CEDAR LAKE AQUATIC ECOSYSTEM RESTORATION FEASIBILITY STUDY

APPENDIX J VALUE ENGINEERING STUDY

**RE: Cedar Lake Ecosystem Restoration Feasibility Study
Sediment Placement VE Evaluation**

Value Engineering Study on the
**Cedar Lake, Indiana
Aquatic Ecosystem Restoration
Feasibility Study**

Figure 2. Supernatant Settling Test Images

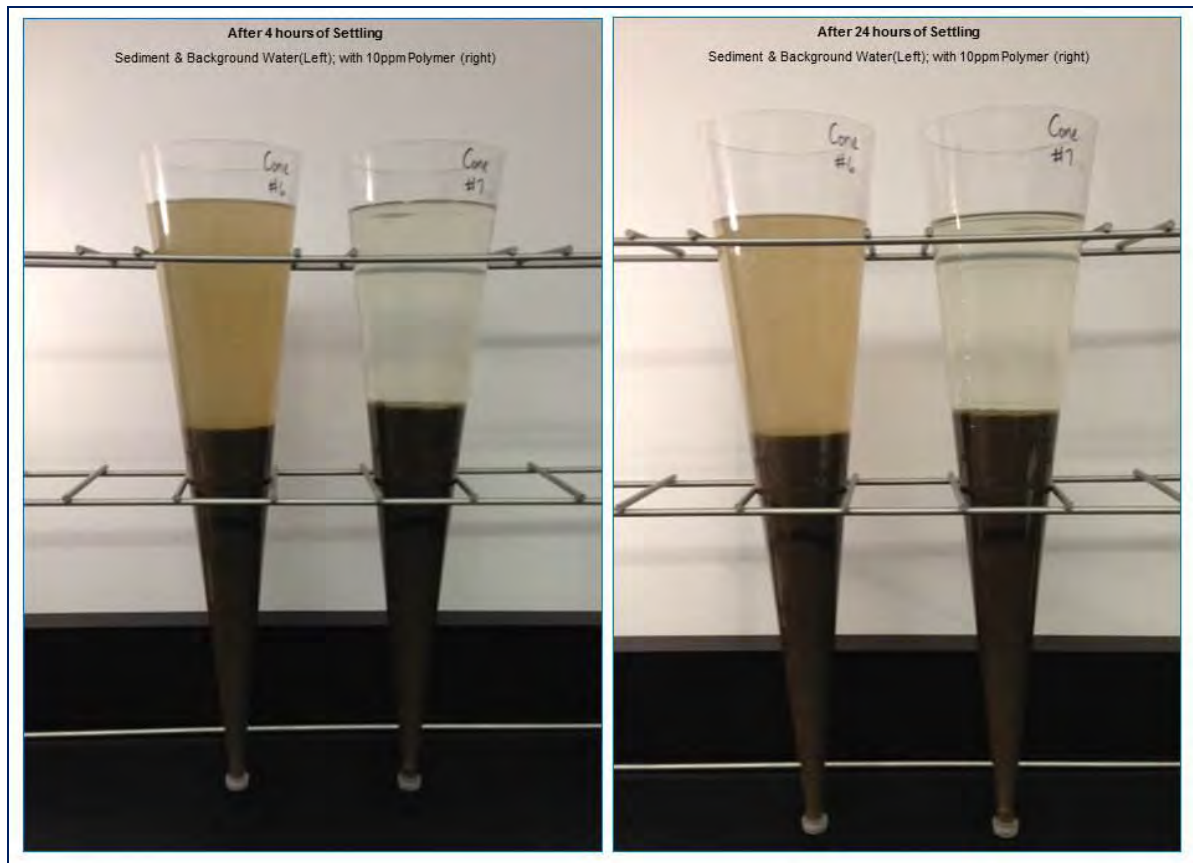
It was observed that a distinct sediment-water interface formed within the first 10 minutes of settling and that after 4 hours, the sediment had self consolidated such that the sediment-water interface was at the 300 ml level for sediment and lake water only, and 340 ml for the mixture with polymer. After 24 hours, the sediment-water interface had dropped to 290 ml and 320 ml respectively. The

Although ammonia-N was relatively high compared to results for TSS and TP, all observed results were significantly lower than the values presented in the 2007 Elutriate Test results. The lake sediment targeted for dredging appears to settle at a predictable rate within a quiescent water column and the sediment-water interface develops rapidly and self consolidated to approximately 30 percent of the overall slurry volume within four hours of gravity based settling. The addition of a

cationic polymer accelerates the settling process and appears to precipitate phosphorus out of the water column, which is typical. Ammonia-N remains somewhat elevated and will require some level of treatment and subsequent conversion to non-toxic forms of nitrogen.
